Technical Service Information

FORD 4R100 PRELIMINARY INFORMATION

CHANGE: Beginning at the start of production for 1999 models, Ford Motor Company introduced a new transmission in some F250, F350, F450 and F550 Super Duty Trucks, equipped with the 5.4L, 6.8L and 7.3L engines. Basically the new 4R100 is a revised version of the previous E4OD transmission with a Power-Take-Off (PTO) window on the side of the case (See Figure 1). The revisions that have occurred however, have created many major engineering changes that have affected many internal and external parts that will affect service.

**4R100 VALVE BODY CHECKBALL LOCATIONS
REQUIRES TWO 1/4" RUBBER BALLS,
AND TWO 5/16" RUBBER BALLS**

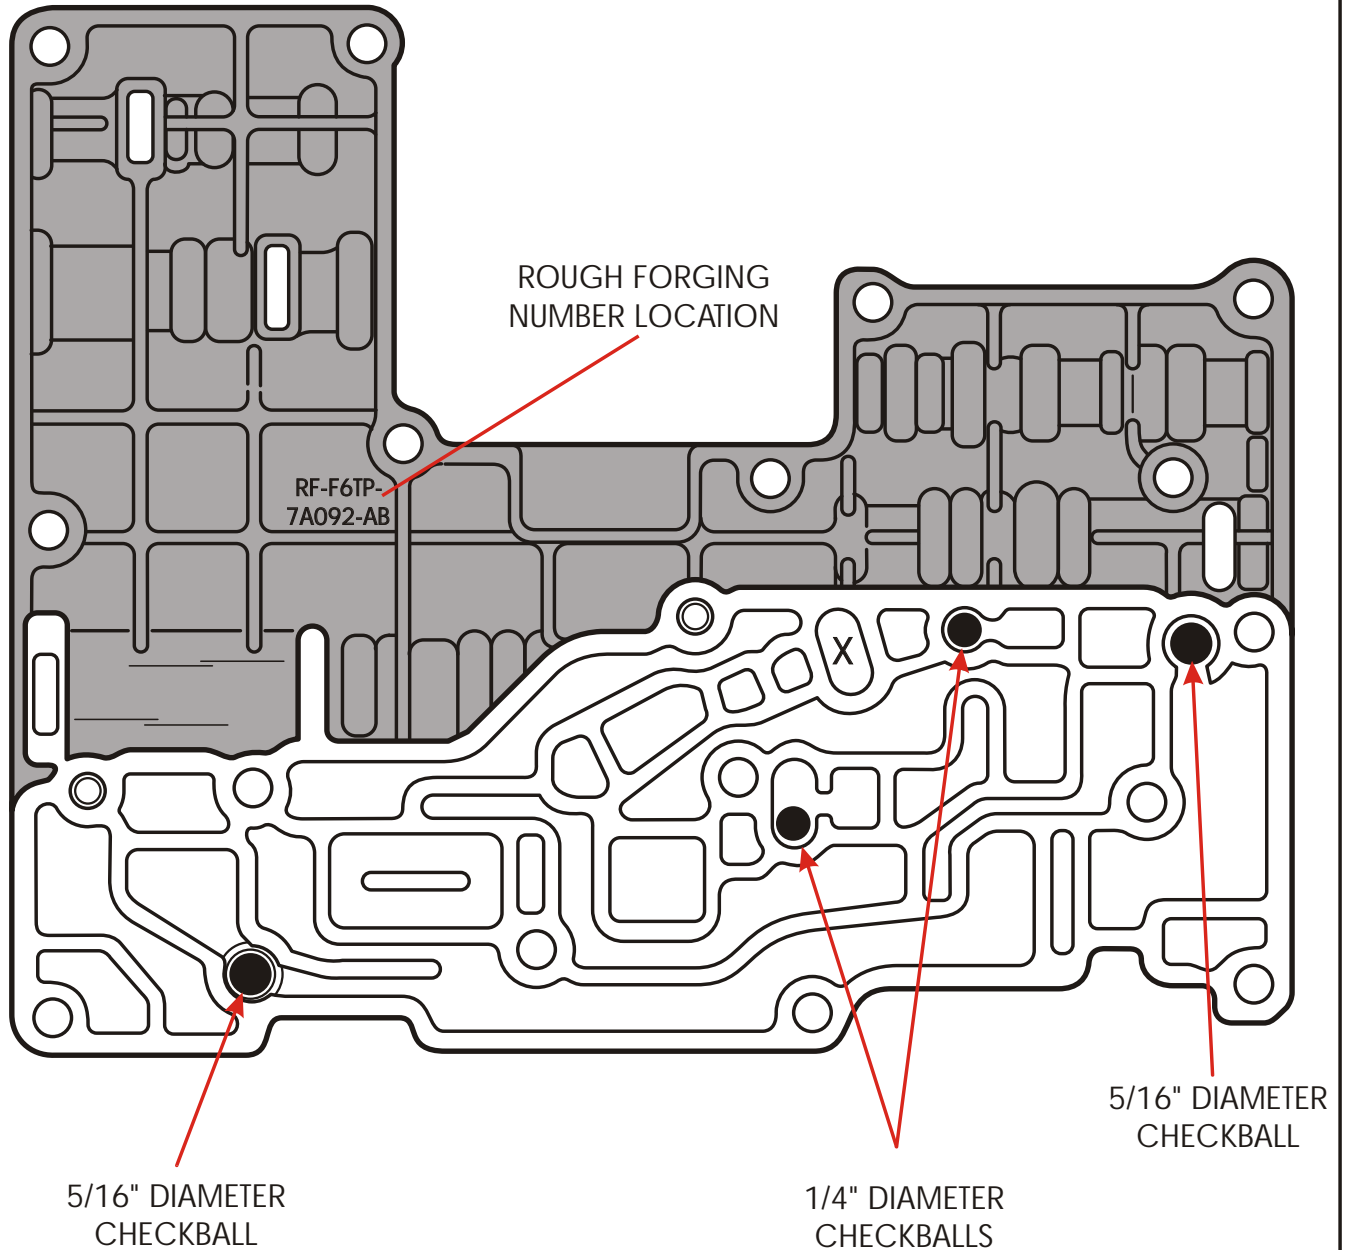
- (15) **VALVE BODY CHECKBALL LOCATIONS** - Valve body checkball locations are illustrated in Figure 15 and now has two 1/4" checkballs and two 5/16" checkballs. This of course changes the lower valve body spacer plate as illustrated in Figure 16. The new design spacer plate has only one hole over the bathtub where the checkball was removed. The case checkball locations remain the same as the 1996-Up configuration, and this illustration is included for reference and shown in Figure 17.

Figure 18
AUTOMATIC TRANSMISSION SERVICE GROUP

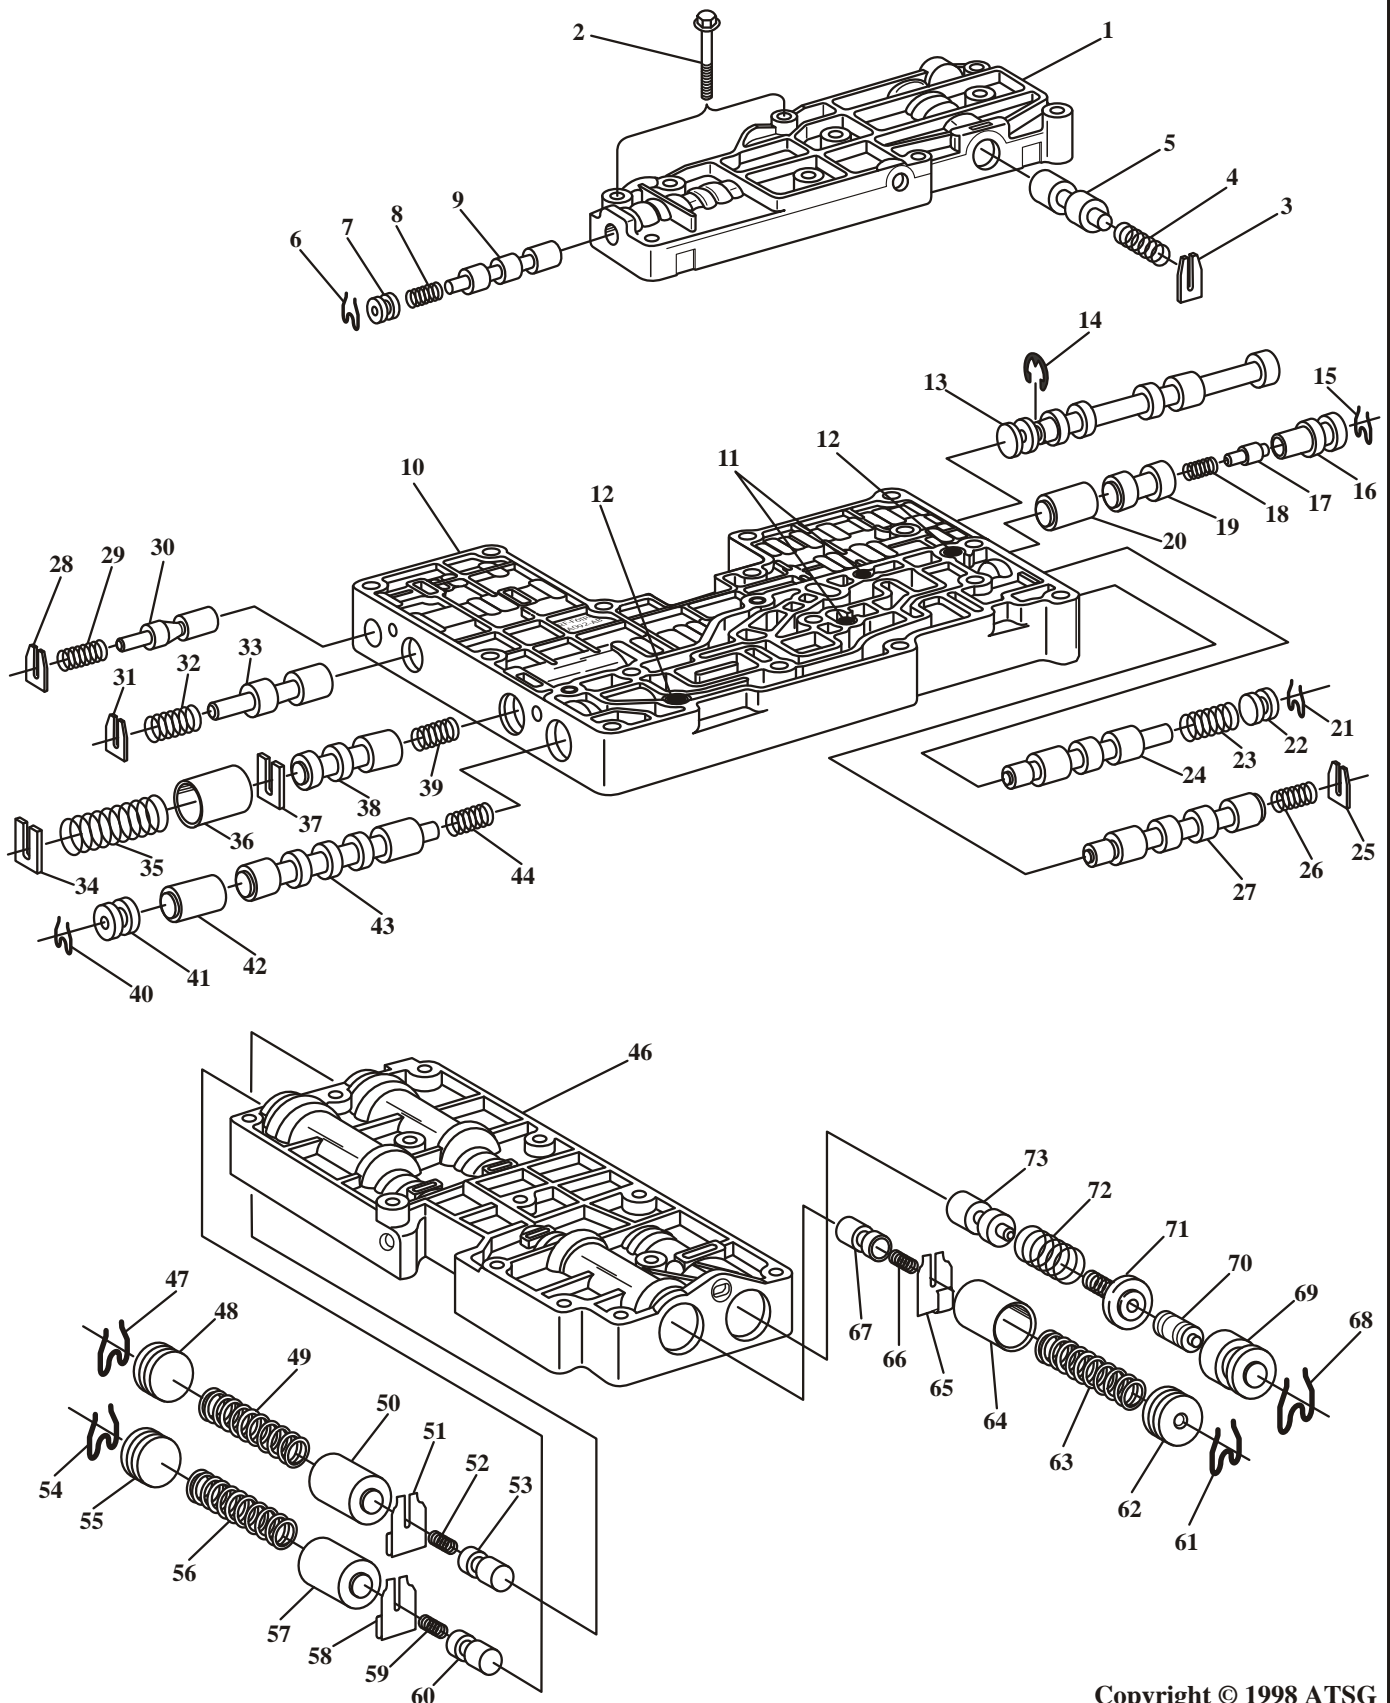
- (16) **VALVE LINE-UPS IN VALVE BODY** - Have changed from the previous models and are illustrated in Figure 18, with a valve description and legend shown in Figure 19.

SOLENOID ASSEMBLY

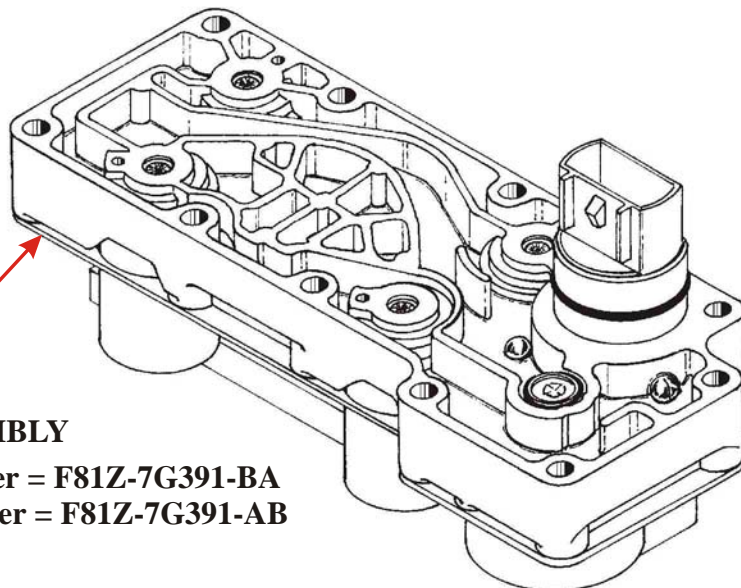
- (17) **SOLENOID BODY** - There are now two different Solenoid Bodies, depending on whether you have a gasoline or diesel model. Since the diesel models now have a Pulse Width Modulated (PWM) converter clutch application, the resistance on the converter clutch solenoid in the Solenoid Body is going to be different. We have included the OEM part numbers for both solenoid bodies and resistance charts for all solenoids in Figure 20, and you will find solenoid application and pin function charts in Figures 21 and 22.

Gasoline Engines Only - Part Number = F81Z-7G391-BA
Diesel Engines Only ----- Part Number = F81Z-7G391-AB
